Flight Procedures Cover Page	Task Action: FLIGHT CHECK	Task Type: IAP	Estimated Chart Date: 07/11/2024	APWS Task ID: 3AE1C893DB4C43B68F1CC7FC081A9352	APWS Project ID: 444D9F9A66DF4BEB87A18BCAD7779C28
Procedure: ILS OR LOC RWY 36L ORIG		Enroute: NO	Specialist: Blanco, Joseph		Agreement Number:
Airport ID: KHRL			Airport City: HARLINGEN		State: TX
Facility ID: RVZ	Facility Type: ILS	Flight Inspection Remark Type: Hold FC Slot

ILS or LOC RWY 36L

VALLEY INTL (HRL)

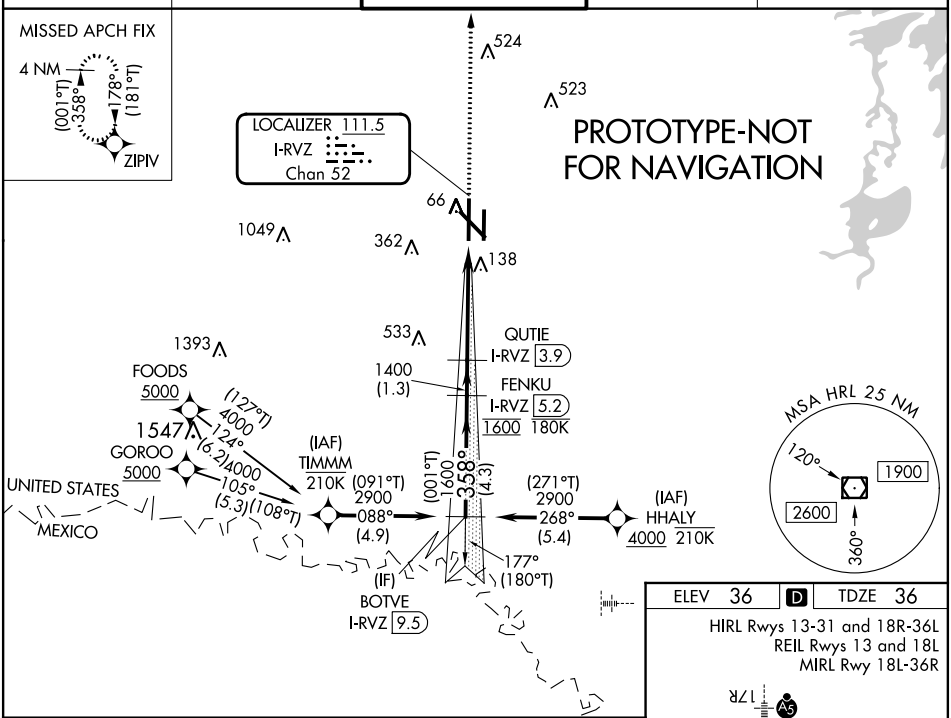
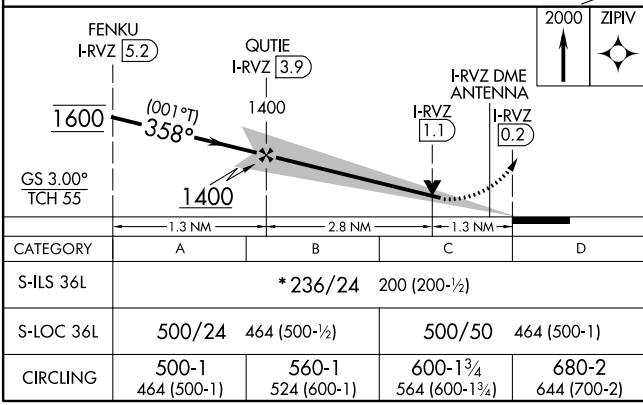
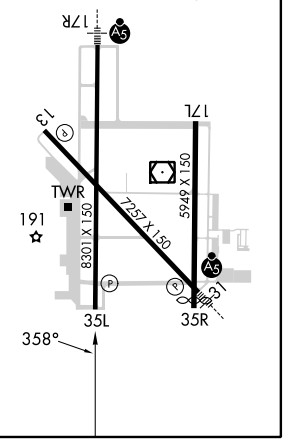
1. TERMINAL ROUTES - REMOVED TF LEGS FROM ALUDE TO FENKU - FLIGHT CHECK REQUESTED AFTER TABLE TOP OF PROCEDURE.
2. TERMINAL ROUTES - REMOVED TF LEGS FROM KAHNS TO FENKU - FLIGHT CHECK REQUESTED AFTER TABLE TOP OF PROCEDURE.

3. TERMINAL ROUTES - CHANGED LEG FROM BOTVE TO FENKU TO BOTVE TO QUTIE - CAPTURE FIX FENKU NO LONGER NEEDED WITH THE REMOVAL OF THE TF LEGS.
4. NOTES - REMOVED NOTE "SEE PLANVIEW FOR MULTIPLE IF LOCATIONS" - IF LOCATIONS AT KAHNS AND ALUDE REMOVED AT FLIGHT CHECK REQUEST.

5. NOTES - REMOVED NOTE "CHART SPEED ICON IN PLANVIEW AT ALUDE: MAX 210 KIAS" - IF LEG STARTING AT ALUDE REMOVED AT REQUEST OF FLIGHT CHECK.
6. NOTES - REMOVED NOTE "CHART SPEED ICON IN PLANVIEW AT KAHNS: MAX 210 KIAS" - IF LEG STARTING AT KAHNS REMOVED AT REQUEST OF FLIGHT CHECK.

7. NOTES - REMOVED NOTE "CHART AT OR ABOVE 4000 AT ALUDE" - IF LEG STARTING AT ALUDE REMOVED AT REQUEST OF FLIGHT CHECK.
8. NOTES - REMOVED NOTE "CHART AT OR ABOVE 4000 AT KAHNS" - IF LEG STARTING AT KAHNS REMOVED AT REQUEST OF FLIGHT CHECK.

9. REMOVED NOTE "CHART SPEED ICON IN PLANVIEW AT FENKU: MAX 180 KIAS" - CAPTURE FIX FENKU NO LONGER NEEDED WITH THE REMOVAL OF THE TF LEGS.
10. REMOVED NOTE "CHART MANDATORY 1600 AT FENKU." - CAPTURE FIX FENKU NO LONGER NEEDED WITH THE REMOVAL OF THE TF LEGS.

11. PROFILE LINE 2 - CHANGED FROM PROFILE STARTS AT FENKU/5.19 DME TO PROFILE STARTS AT BOTVE/9.48 DME - FENKU REMOVED FROM PROCEDURE, RESULTING IN THE COMMON FIX BOTVE BEING THE NEW PROFILE START.

12. PROFILE LINE 4 - REPLACED FENKU FIX WITH BOTVE - FENKU REMOVED FROM PROCEDURE, RESULTING IN THE COMMON FIX BOTVE BEING THE NEW PROFILE START.

04/26/24: THIS IS A CORRECTED COPY OF THE FORM APPROVED ON 04/22/2024. J ZEDER 04/26/2024
1. ADDED NOTE "VGSI AND ILS GLIDEPATH NOT COINCIDENT (VGSI ANGLE {ANGLE}/TCH {FEET})" - IAW 8260.19I 8-6-9.
